Access Compliance Report

Public Rights-of-Way

(Curb Ramps)

Intersection ID: 53623	Main Street: JIMMY_OEHLER_RD	Cross Street: OEHLER_BRIDGE_DR	Location: W
ADA ID: 04CCC701015E	Ramp Type: Perp	Initial Pass/Fail: Fail	Overall Compliance: No
		Severity Score: 10

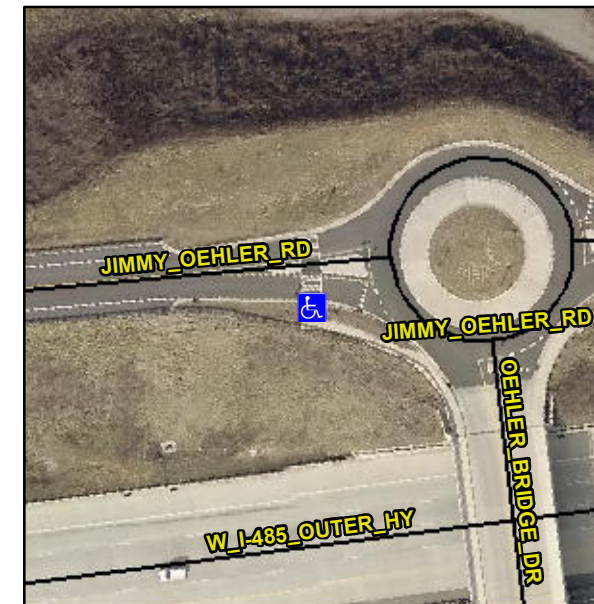
R304.5.1, R304.5.3

Compliance	Description	Data	Compliance	Description	Data
N/A	Ramp Length (in)	90.0	Yes	Ramp Slope (%)	6.5
No	Ramp Width (in)	44.0	No	Ramp XSlope (%)	3.1
N/A	Flare Type LT	N/A	N/A	Flare Type RT	N/A
N/A	Flare Slope LT (%)	N/A	N/A	Flare Slope RT (%)	N/A
N/A	Flare Traversable LT?	N/A	N/A	Flare Traversable RT?	N/A
N/A	Landing Length (in)	N/A	N/A	DWS Provided?	N/A
N/A	Landing Width (in)	N/A	N/A	DWS Contrast?	N/A
N/A	Landing Slope (%)	N/A	N/A	DWS Length (in)	N/A
N/A	Landing X Slope (%)	N/A	N/A	DWS Full Width?	N/A
N/A	Landing Curb? (Y/N)	N/A	N/A	DWS Offset (in)	N/A
N/A	Shared Landing?	N/A			
N/A	Gutter Ponding?	N/A	N/A	Gutter Slope (%)	N/A
N/A	Gutter Lip Ht (in)	N/A	N/A	Gutter X Slope (%)	N/A
N/A	Painted X Walk1?	Yes	N/A	Painted X Walk2?	N/A
	X Walk 1 Direction	To N		X Walk 2 Direction	N/A
N/A	X Walk 1 Width (in)	105.0	N/A	X Walk 2 Width (in)	N/A
	X Walk 1 Slope (%)	3.6		X Walk 2 Slope (%)	N/A
	X Walk 1 X Slope (%)	1.4		X Walk 2 X Slope (%)	N/A

Remove & Replace Entire Ramp.
